Product hierarchy no. *				Part no.	SBU	Type / Description	Customer part no.
SBU	PG	PUG	Type				
02	005	016	0000001105	See list below	Power Entry Modules w/o Filter	6205

Product Change Notification					PCN 6205		
owner	creation date	release date	released by	change order no	rev	page	D10-007-429
schaidro	2016-08-24	2016-12-06	buerglal	2011605	A	1 of 2

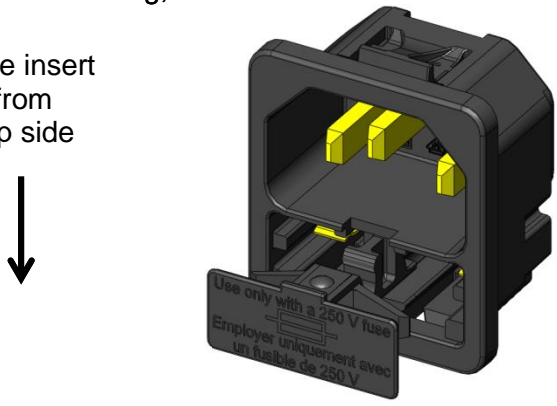
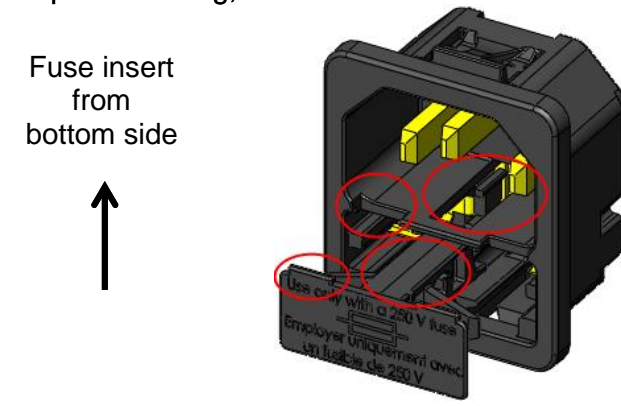
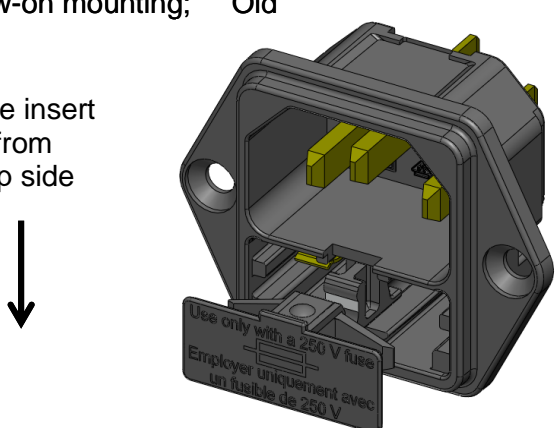
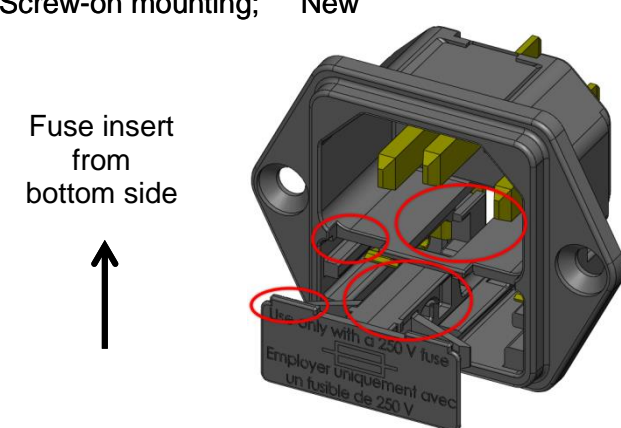
Old product appearance		New product appearance	
<ul style="list-style-type: none"> <li>- Slot for V-Lock cord retention</li> <li>- Fuse assembling from opposite side</li> <li>- Fusedrawer has two latches on the side to pull-out the fusedrawer, until now is only one latch</li> </ul>			
<p>Snap-in mounting; Old</p> <p>Fuse insert from top side</p> 	<p>Snap-in mounting; New</p> <p>Fuse insert from bottom side</p> 		
<p>Screw-on mounting; Old</p> <p>Fuse insert from top side</p> 	<p>Screw-on mounting; New</p> <p>Fuse insert from bottom side</p>

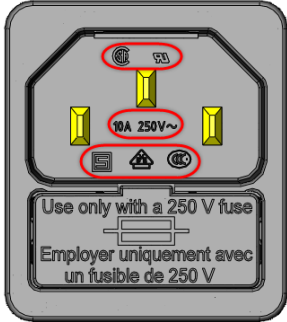
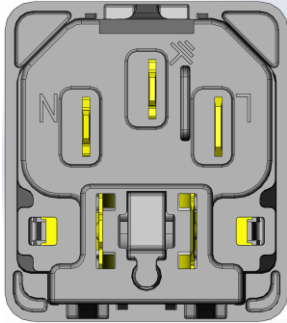
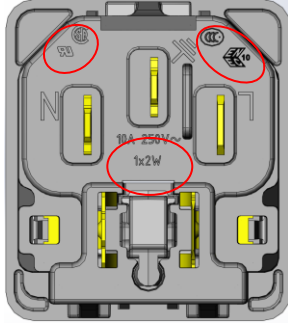
Old product approval marks	New product approval marks
Picture shows snap-in mounting, change also applies to screw version. All approval and rating marks are new on the rear side	
<p>Old;</p>  	<p>New;</p>
